RECEIPT DATE: 4/6/17 **ONSITE SEWAGE DISPOSAL SYSTEM** P 560598
 APPROVAL DATE: 3/16/18 sec **PERMIT: CONSTRUCTION** A _____
 PROPERTY ADDRESS: 8593 Reservoir Road
 SUBDIVISION: Munro Property LOT: 3 TAX ID: 05-598280
 CONTRACTOR: Farm and Home Excavating EMAIL: _____
 CONTRACTOR ADDRESS: 901 Driver Rd, Marriottsville, MD 21104 PHONE: 410-984-0189
 PROPERTY OWNER: Davis and Irina Schuman EMAIL: Dschuman1@gmail.com
 OWNER ADDRESS: 11 Ridge Road Unit 2, Greenbelt, MD 20770 PHONE: 301-513-9322
 SEPTIC TANK SIZE (GALLONS): 1500 TANK MANUFACTURER: Unkwn
 PUMP MODEL: _____ PUMP SIZE _____ PUMP TANK CAPACITY: _____

From: Bricker, Robert [<mailto:RBricker@howardcountymd.gov>]
Sent: Tuesday, December 27, 2016 11:27 AM
To: Peter Andrulis <Peter@sillengineering.com>
Subject: Schumer residence_OSDS Plan

PLOT PLAN
SCHUMAN PROPERTY- MUNRO LOT 3
 8593 RESERVOIR RD. FULTON, MD 20759

**ONSITE SEWAGE DISPOSAL SYSTEM DESIGN PLAN
 SCHUMAN PROPERTY- MUNRO LOT 3**

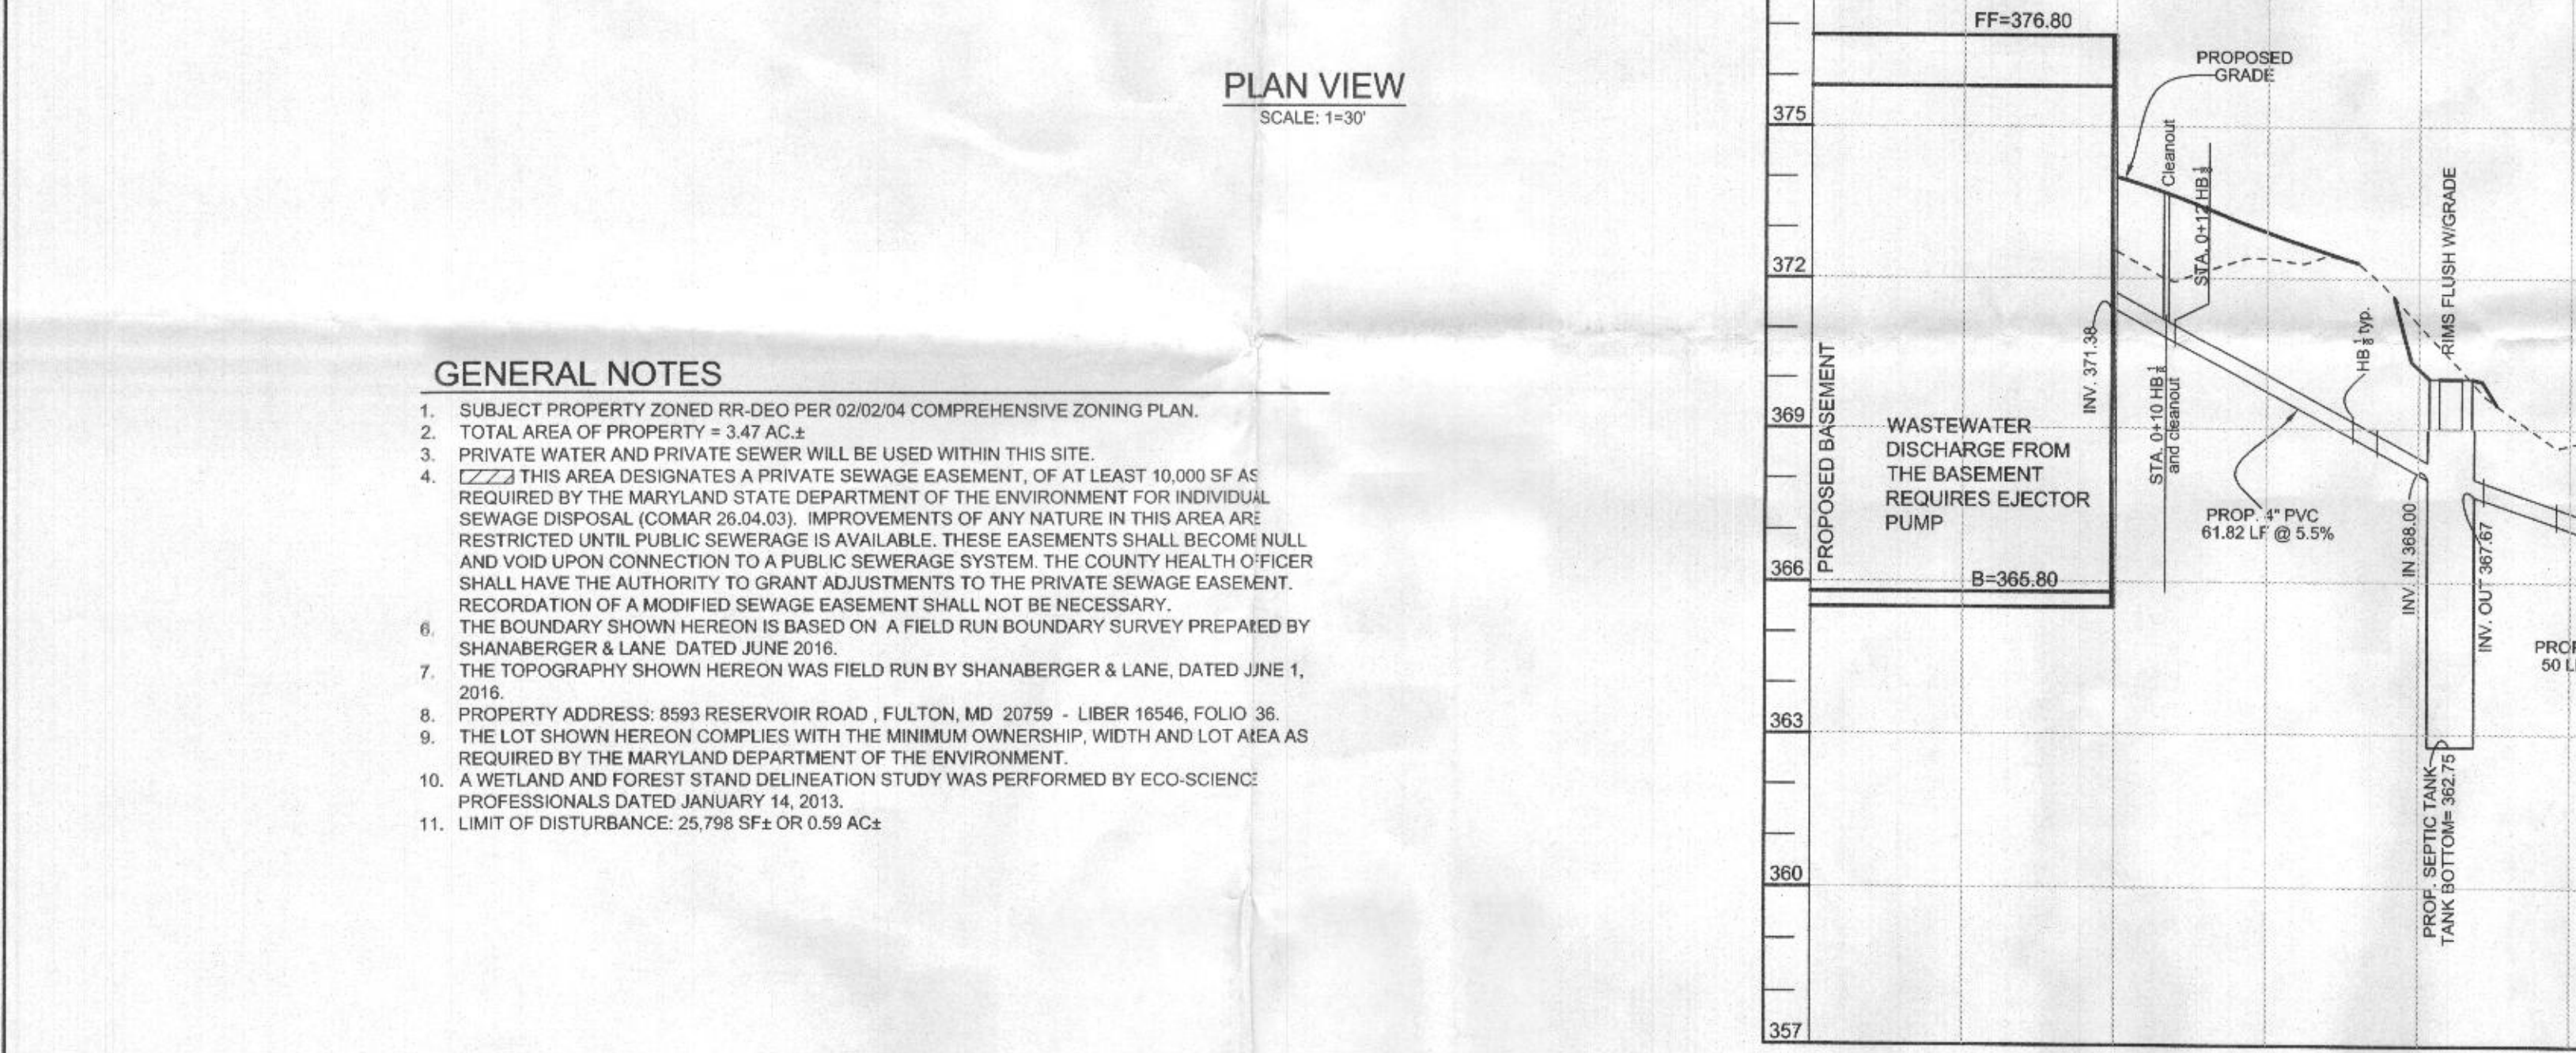
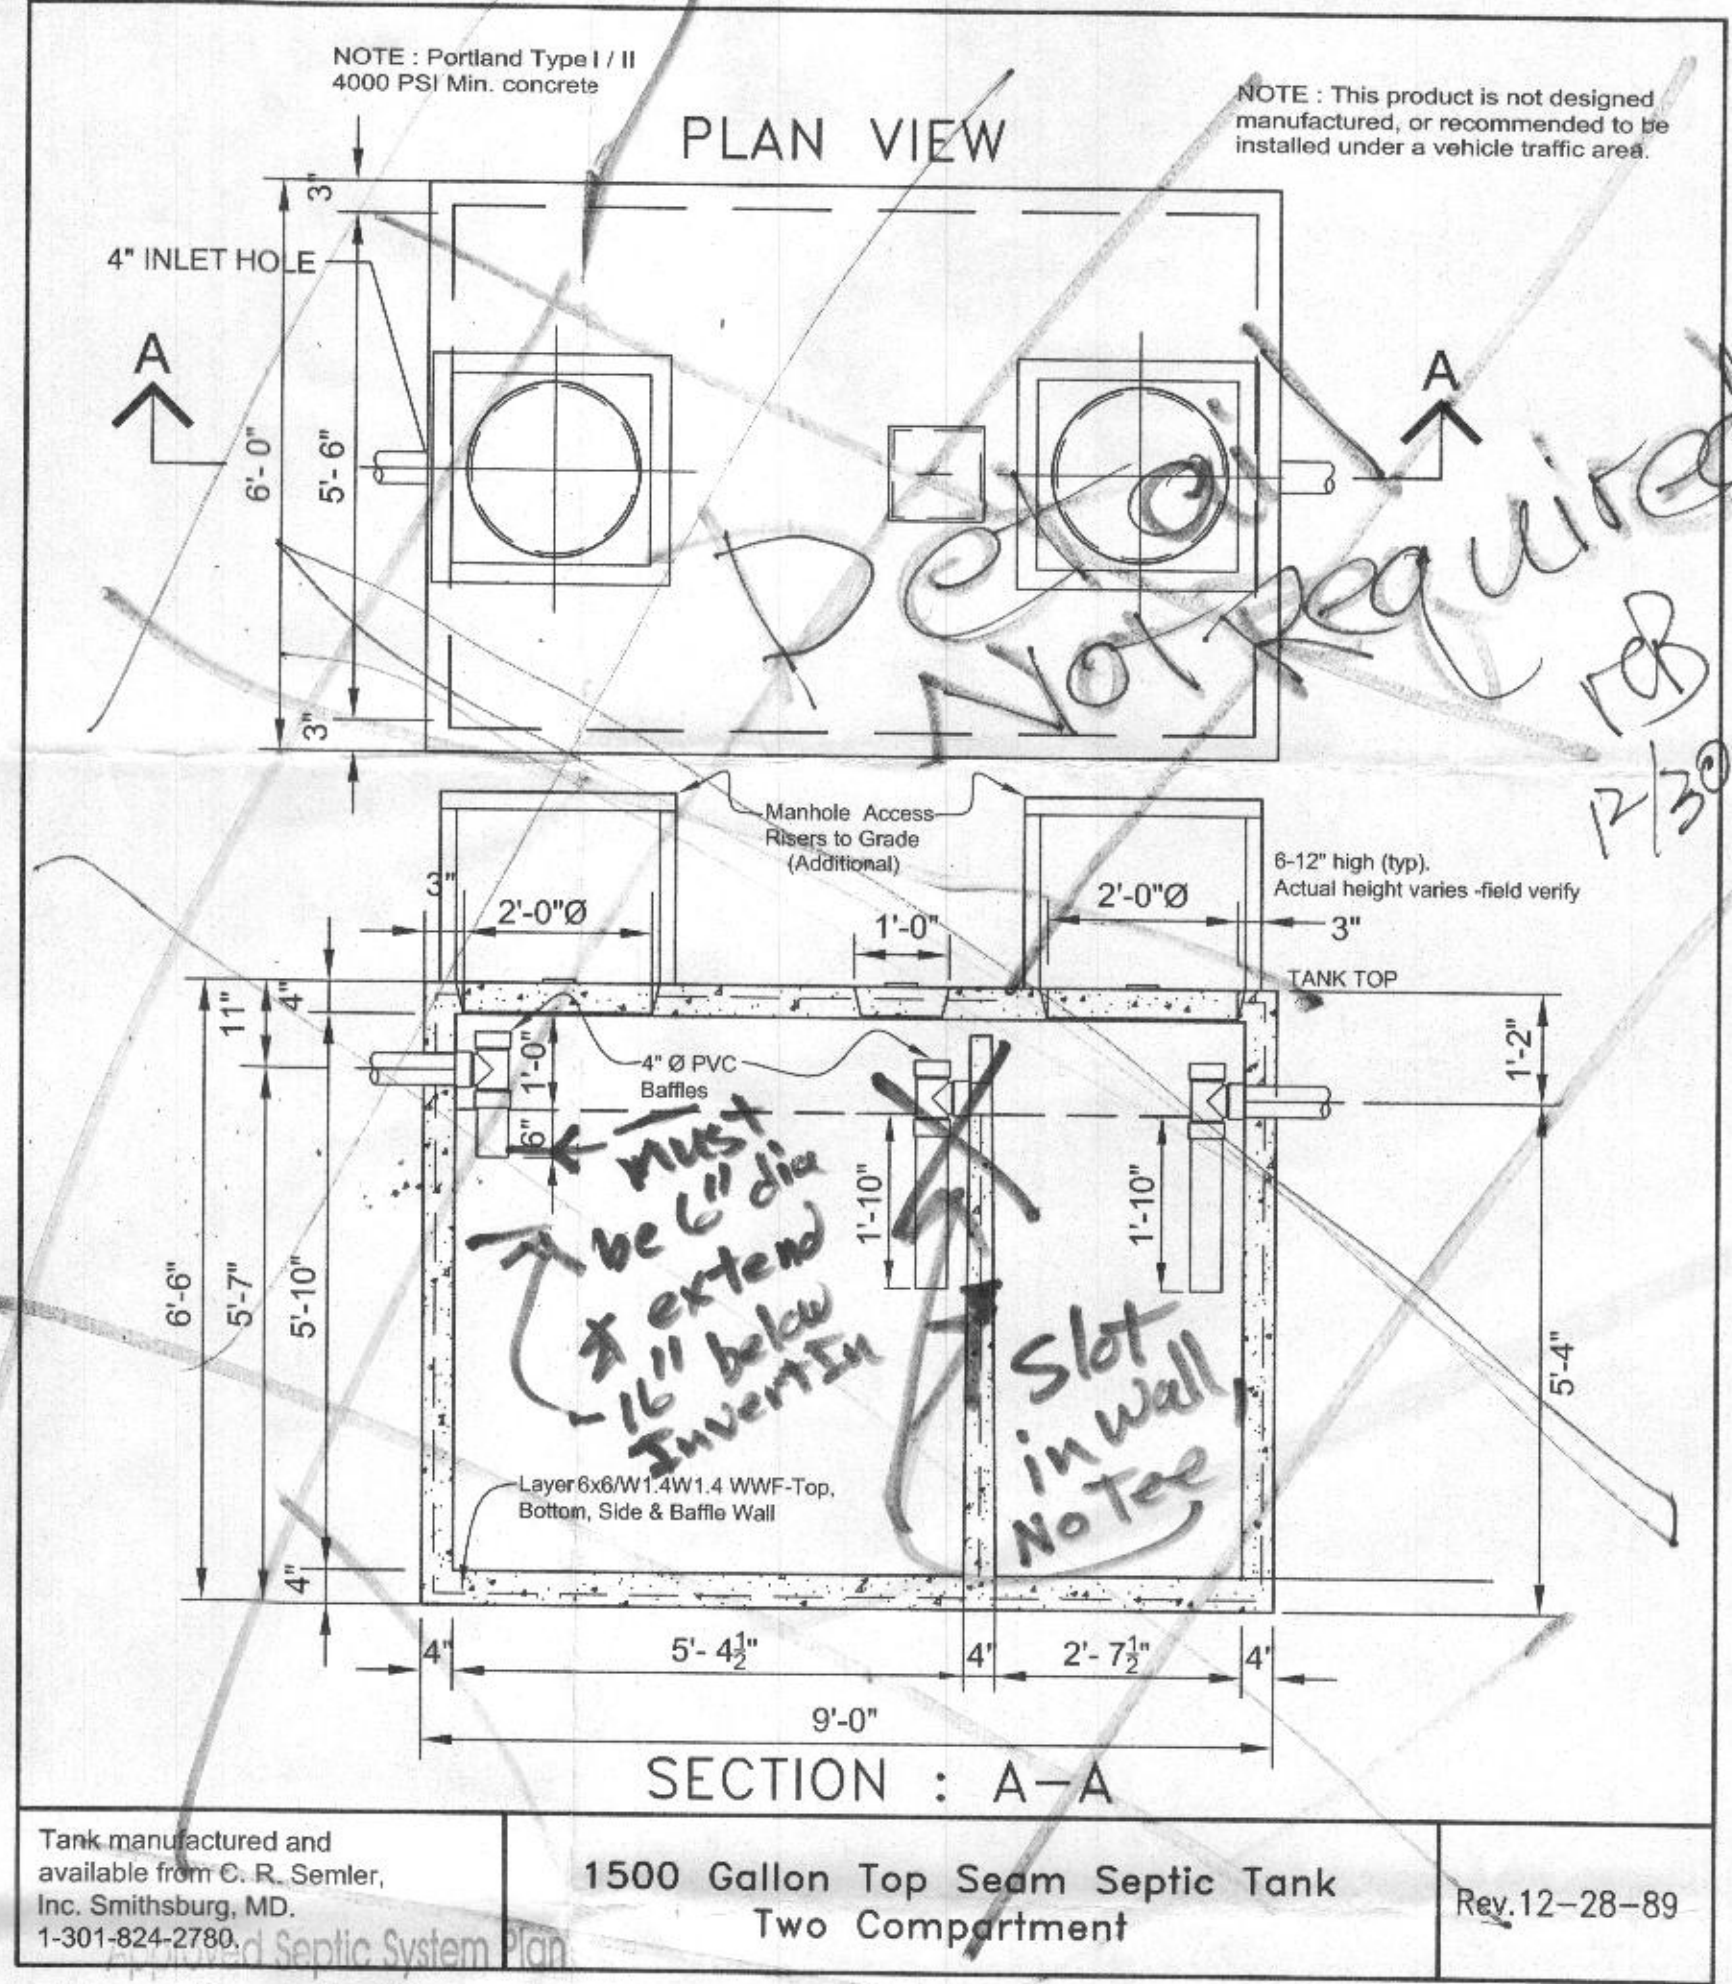
Peter, Here are some needed corrections that I missed earlier:
In SEPTIC SYSTEM PROFILE,

Top of Box Elevation isn't necessary, and the (distribution) box is illustrated oddly with the top at the surface.
Proposed Septic Trench I1 has a bottom at elevation 360.5.

Under SEPTIC SYSTEM DESIGN SPECIFICATIONS,

Initial System, Trenches I1 and I2 do not have equal Elevations for Grade and Invert

Grade at Trench I1=367.5; Grade at Trench I2 = 366.0

Invert for Trench I1 = 364.5; Invert for Trench I2 = 363.0

Reverse the labels for Replacement System trenches so that R1 is the higher trench

Replacement System Trenches R1 and R2 do not have equal Elevations for Grade and Invert

Grade at R1 = 367.5; Grade at R2 = 365.5

Invert for R1 = 364.5; Invert for R2 = 362.5

plus I made the rims level at 1' of a riser height
and took care of the dist. box odd top. Mr. Sill wanted them that way
but I have fixed them at your request.

I have reworded the note # 6 to read correctly,

cleaned up those R trenches and added a revision date to the revision block.
